DEVELOPMENT and PLANNING SERVICES COMMITTEE

Development Services Department Memorandum

SUBJECT: Variance Permit Application No. VP-466 (Servicing)
 Legal: Lot 3, Section 19, Township 20, Range 9, W6M, KDYD, Plan 3804
 Civic Address: 3200 – 30 Avenue NE
 Owner: 1129288 BC Ltd.
 Applicant: Blake Lawson, Lawson Engineering and Development Ltd.

To: Kevin Pearson, Director of Development Services
 Date: October 30, 2017
 Prepared by: Darin Gerow, Engineering Assistant
 Subject: **DEVELOPMENT VARIANCE PERMIT APPLICATION NO. VP- 466E
 AMMENDMENT #1**
 Legal: Lot 3, Section 19, Township 20, Range 9, W6M, KDYD, Plan 3804
 Civic: 3200 – 30 Avenue NE
 Owner: 1129288 BC Ltd., 3481 – 4 Avenue SE, Salmon Arm, BC, V1E 1N3
 Applicant: Owner
 Associated: SUB 17-22

PRELIMINARY
SUBDIVISION SKETCH
PLAN

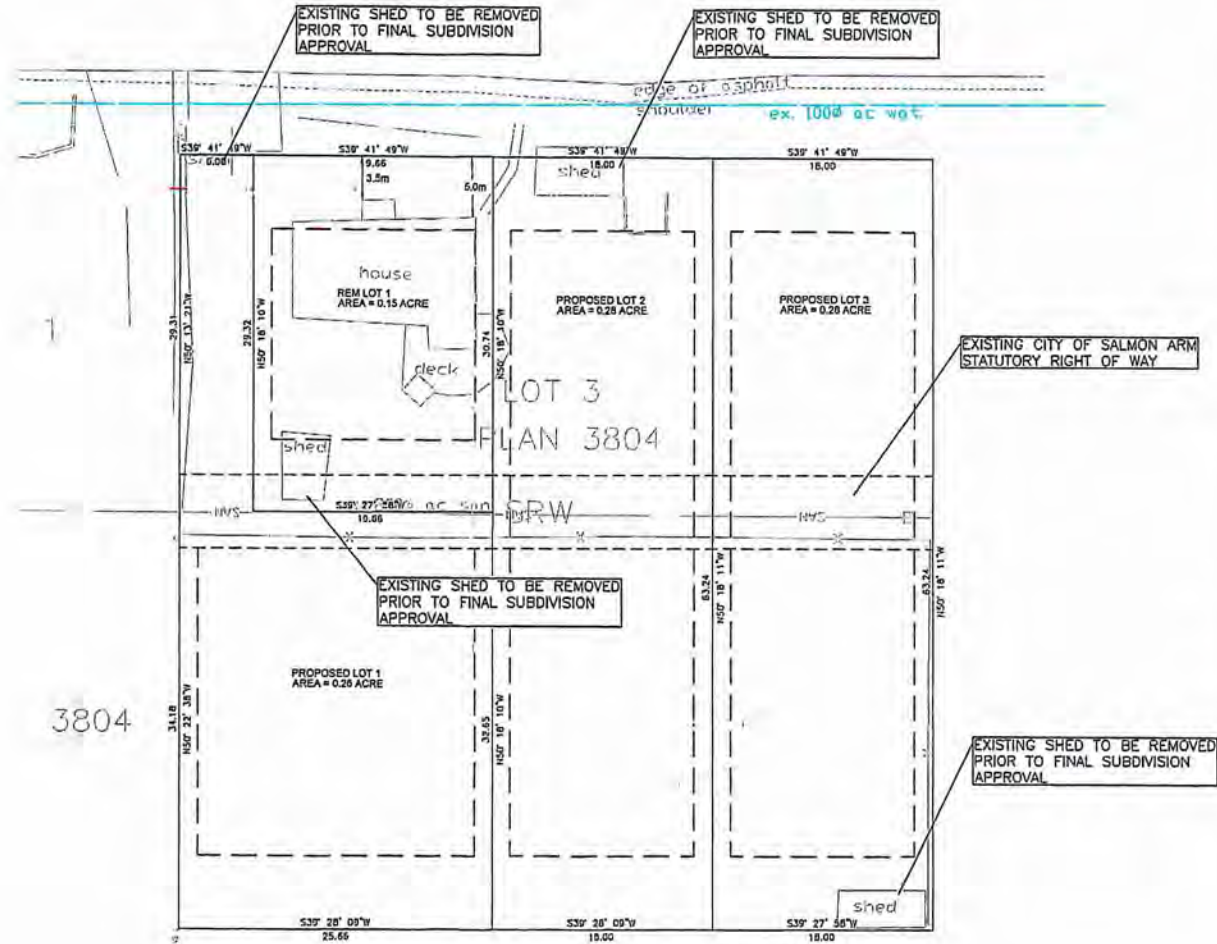
The proposed sketch plan of the subdivision is attached as APPENDIX 3 and a letter of rationale is attached as APPENDIX 4.

Further to the variance permit application for subdivision application number 17.22 this letter is intended to provide insight into the variance the developers and Lawson Engineering and Development Services Ltd. (LEDS) have proposed regarding this application. The variance proposed is requested for the reasons stated below and to allow the developer to maximize the development potential of the subdivision. In addition, these variance request is consistent with similar variances that have been granted along 30th Avenue NE in the recent past.

- 1) Reduce the requirements to upgrade the South half of the road from an urban local standard (RD-2) to a rural local standard (RD-7).
 - a) The reason for this is that the property borders the urban containment boundary and is next to rural properties within the ALR. There is a low likelihood that any dense development will occur on either the West or East side of this property and therefor it does not seem practical to construct a small strip of urban local road at this location.

- b) One property to east and one property to the west have been granted a similar variance, and the roads have been constructed to this rural standard. We are also requesting this variance for consistency along this section of 30th Avenue NE.

- c) With regards to storm water and specifically road drainage, an Integrated Stormwater Management Plan (ISMP) will be required, as per the City Subdivision and Development Servicing Bylaw. Using the rural road cross-section and larger lots we will propose to distribute the flows throughout the frontage providing the opportunity for infiltration and disbursement of road drainage throughout the 62m of frontage, rather than localizing the flow to a single point of disbursement.

SPECIFICATION
DRAWING No.
RD-2

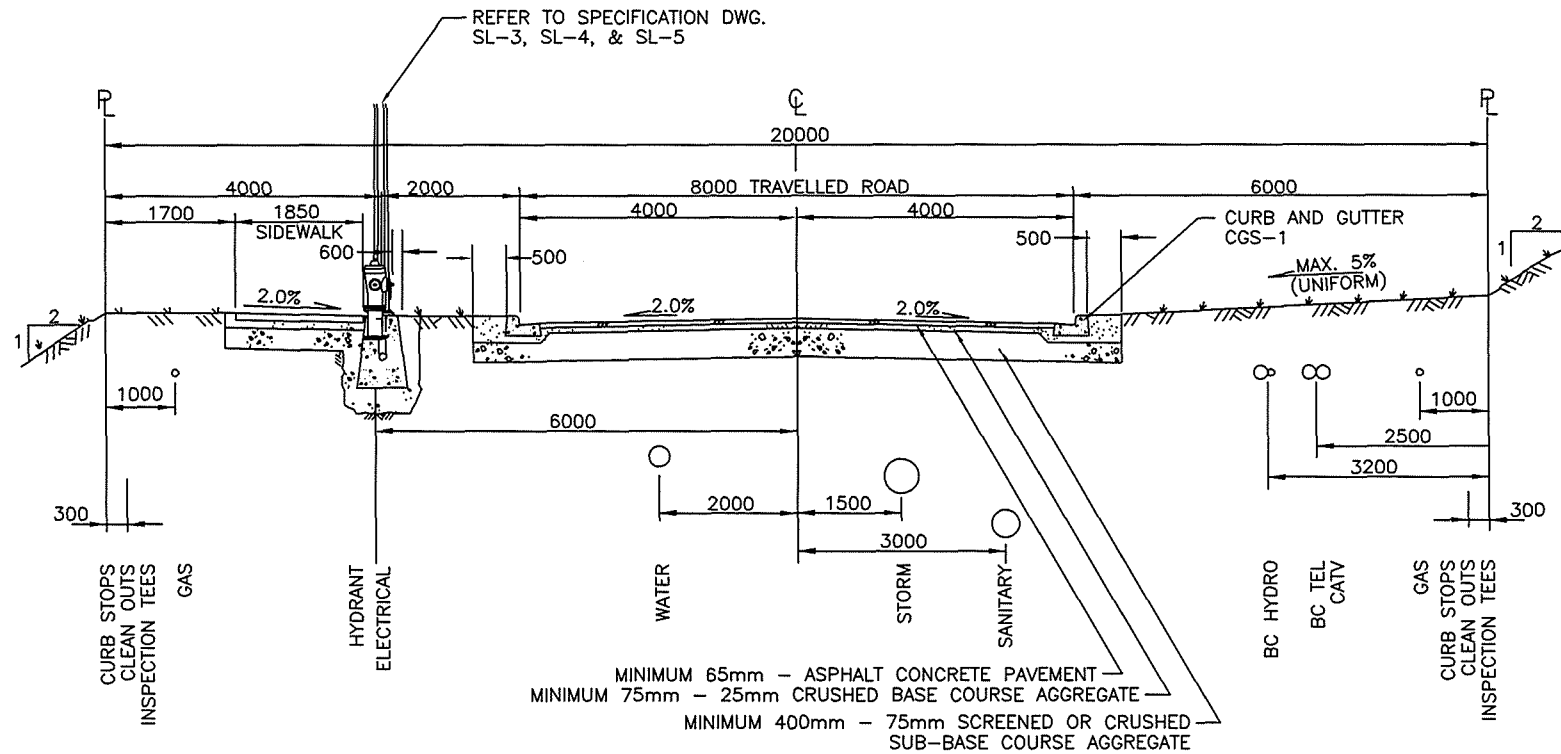
30 Avenue NE is currently constructed to an interim paved standard. The SDS Bylaw would require the south half of the road be upgraded to the Urban Local Road (RD-2) standard which may include road widening and construction, curb & gutter, sidewalk, boulevard construction, street lighting, fire hydrants, street drainage and hydro/telecommunications. The applicant has requested to reduce this requirement to the Rural Local (RD-7) standard, which may include road widening and construction, fire hydrants, ditching and boulevard construction. RD-2 and RD-7 cross sections are attached as APPENDIX 6.

1) Variance request to reduce the requirement to upgrade the south half of 30 Avenue NE from an urban local standard (RD-2) to a rural local standard (RD-7).

Subdivision and Development Servicing Bylaw No. 4163 requires that all adjacent street frontages be upgraded to the local road standard at time of subdivision or development. 30 Avenue NE is classified as an Urban Local Road and is currently constructed to an interim paved standard.

Upgrading 30 Avenue NE may include, but is not limited to, road widening and construction, curb and gutter, sidewalk, boulevard construction, street lighting, fire hydrants, street drainage and hydro and telecommunications.

We recommend that the variance requested be granted. As this property is located on the edge of the Urban Containment Boundary we feel a rural road standard is acceptable, and ditch drainage may be more beneficial in this specific circumstance.

CITY OF SALMON ARM			20m R/W Rural Local Road Cross-Section		
No.	Revision	Date	Date	Approved	SPECIFICATION DRAWING No.
A	ISSUED FOR APPROVAL	07/14/16	10-11-2016	<i>[Signature]</i> City Engineer	RD-7

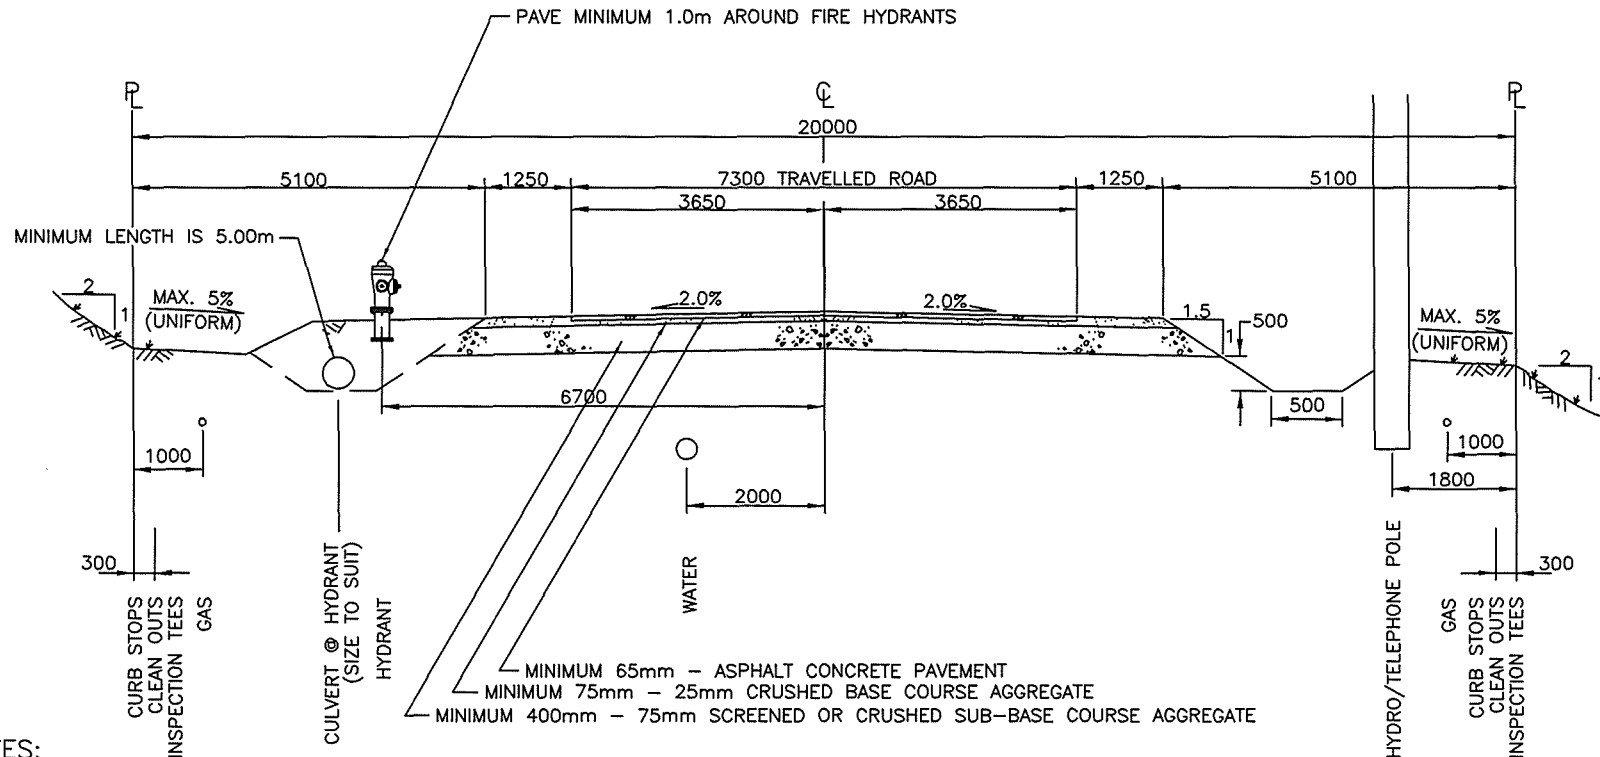
A Rural Road Standard, as the applicant has requested, may include, but is not limited to, Road widening and construction, fire hydrants, ditching and boulevard construction.
